294-295 HIGH HOLBORN, LONDON WC1

Planning: [**Design & Access Statement addendum**]

MSMR Architects [*project number: 20004*]

June 2020

3.1.2 proposed basement floor

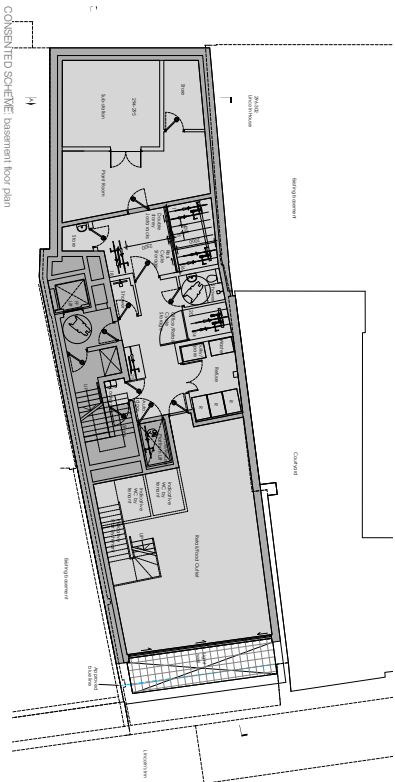
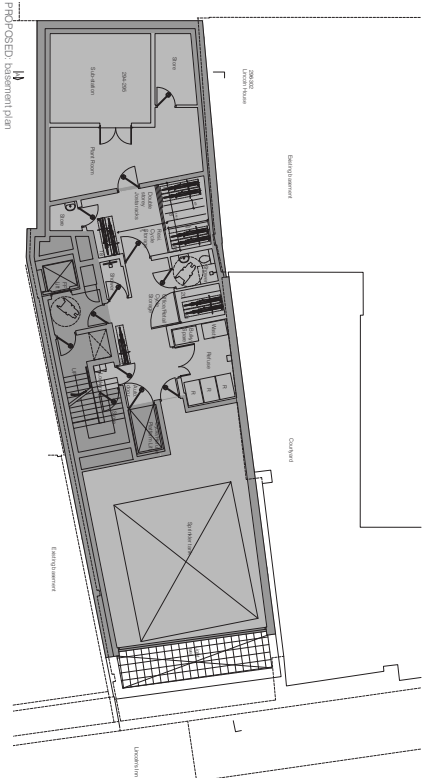
In order to deliver the consented design and comply with current and emerging changes to the building regulations, an OH1 commercial sprinkler system is proposed in accordance with BS EN 12845.

An OH1 commercial sprinkler system requires an 80m³ tank. It is proposed to locate the tank at basement level in lieu of the retail space.

In addition the glazed sliding doors to the lightwell will be replaced with a metal boarded screen to provide basement smoke ventilation.

3.2.2 proposed third and fourth floors

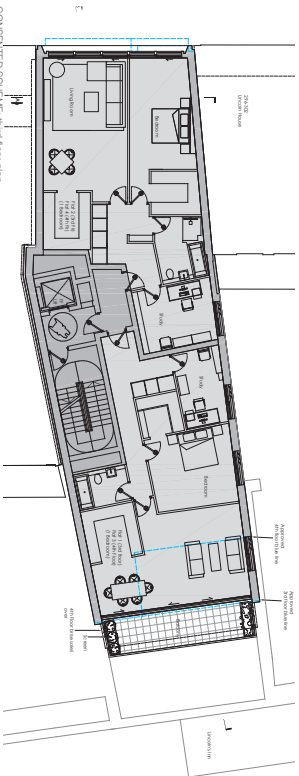
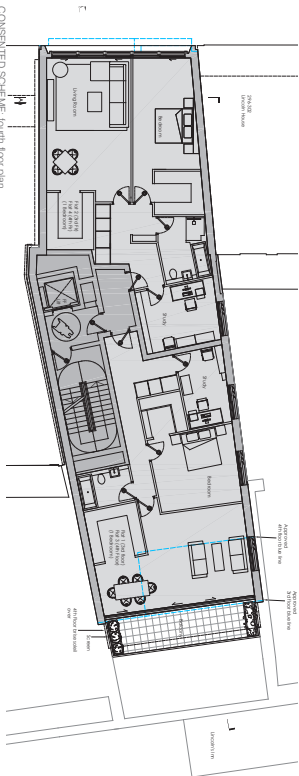
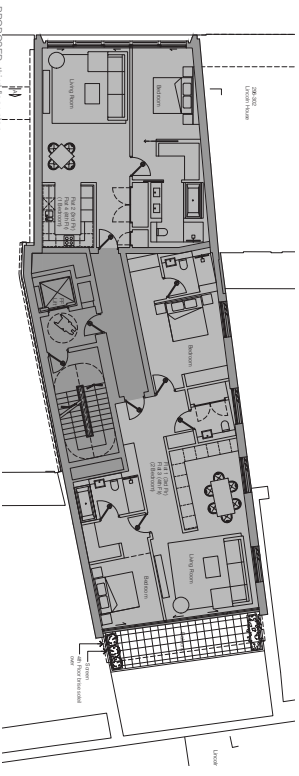
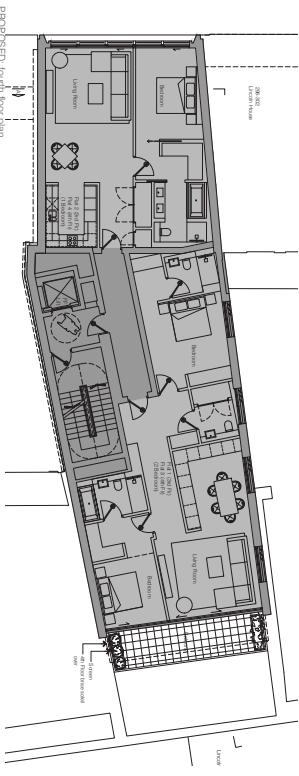
- Observations:
- Small common lobby
 - Southern aspect is better suited to residential use
 - Quiet, green spaces, balconies and improved natural light

- Changes proposed include:
- Generous common lobby added
 - Wall between apartments repositioned to reduce the size of the north facing apartments and increase the size of the south facing apartments. This results in a more efficient north facing 1 bed apartment and a generous south facing 2 bed apartment.
 - The master bedroom in the south facing apartment is repositioned so that it takes advantage of the improved natural light and views of Lincoln Inn. It also gains access to the external balcony.
 - Apartment types are open plan allowing natural light into hallways.

3.3.2 proposed fifth and sixth floors

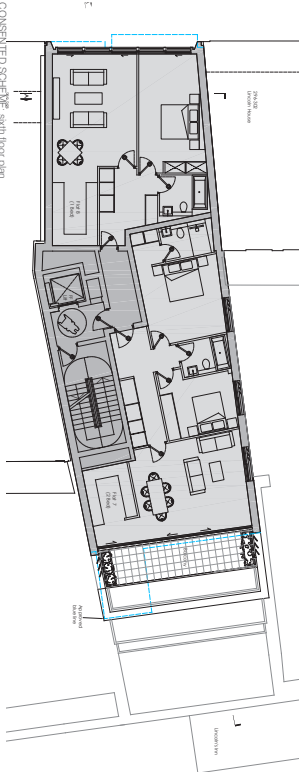
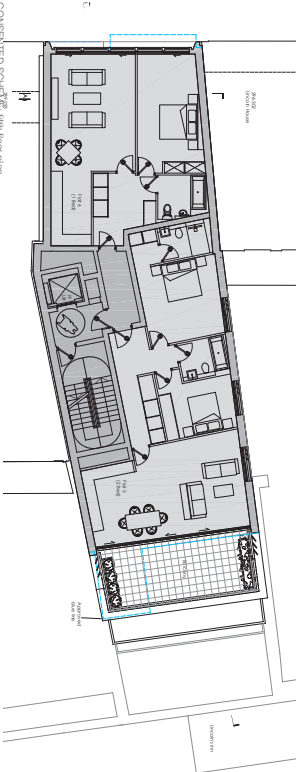
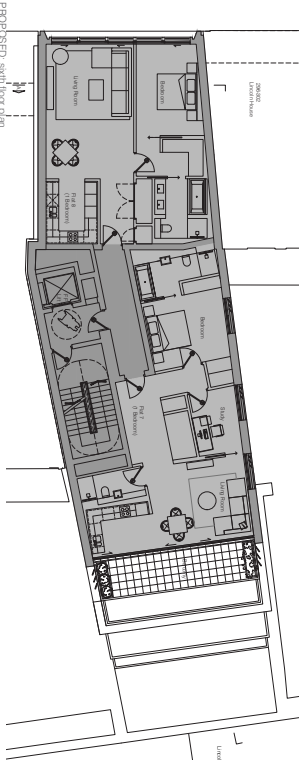
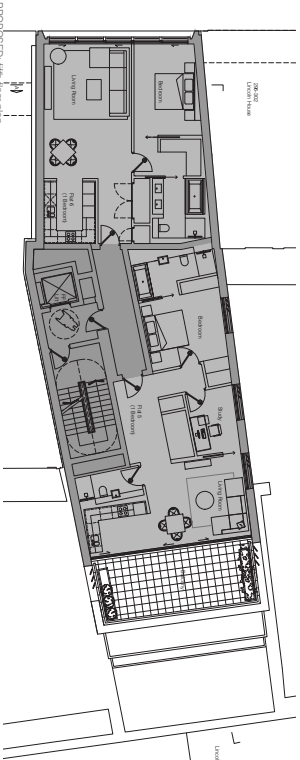
- Small common lobby
- These apartments do not stick with third and fourth floors which makes coordination of vertical services more difficult.
- Bath bedrooms in the south facing apartment type have oblique views to Lincoln's Inn.

- Generous common lobby
- The efficient north facing 1 bed apartment type at third and fourth floors is replicated on these floors and improves stacking.
- The south facing apartments provide 1 bed plus study and takes account of the steeper floor plate. This maintains the consented unit mix to enable more generous 2 bed apartments at third and fourth floors.

3.4.2 proposed seventh and eighth floors

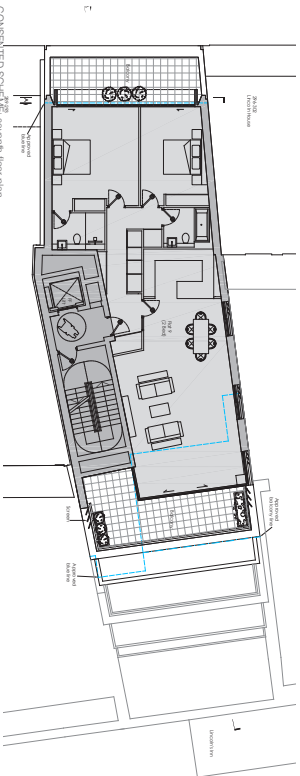
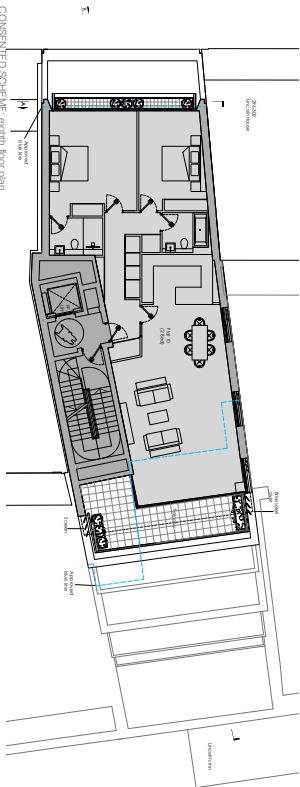
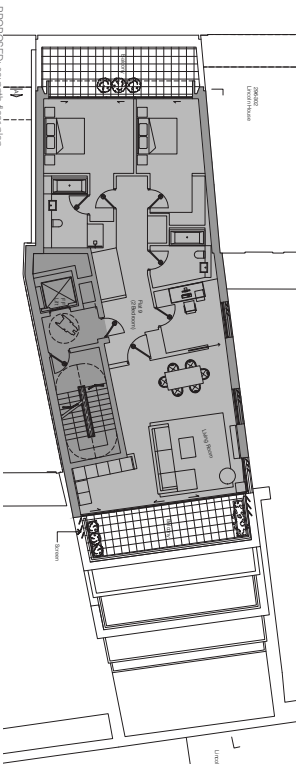
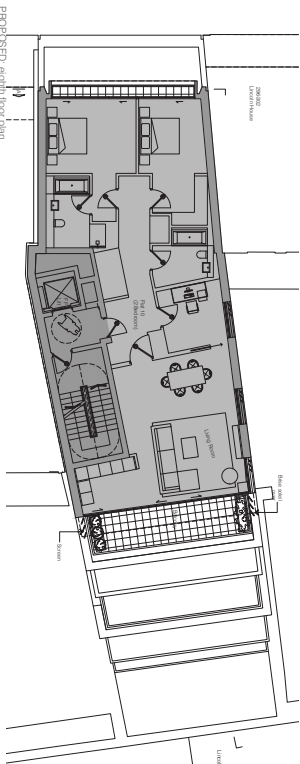
- Changes proposed include:
- Common area immediately south of the staircase is omitted as it is not needed at seventh and eighth floors.
 - Extension to the building envelope at both floors to fill the southern terrace to allow the kitchen to be refitted. The change allows a study room to be added. As these building extensions do not project beyond the consented west return wall they do not change the west elevation or the perceived building mass.

Proposed: south elevation

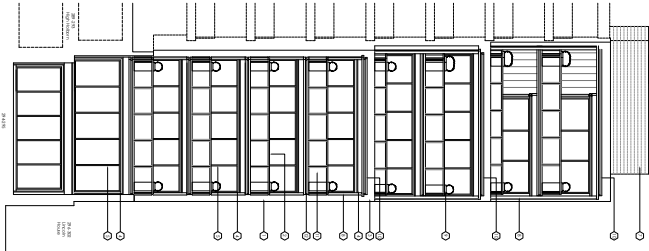
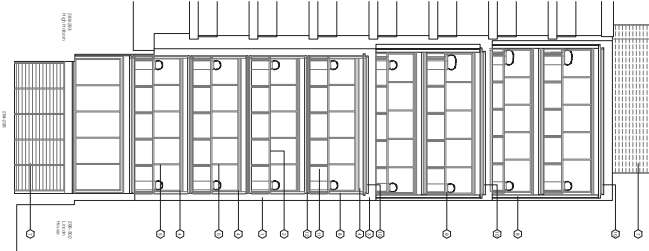
- Polyester powder coat finished louvre screen added at basement level in line of the glazed sliding door as described in section 3.1.2. This part of the elevation will not be visible from neighbouring properties.
- Extension of the building envelope at seventh and eighth floors to partially fill the new terraces as described in section 3.4.2. It is proposed to extend the glazed sliding doors to replicate the rhythm of lower floors.
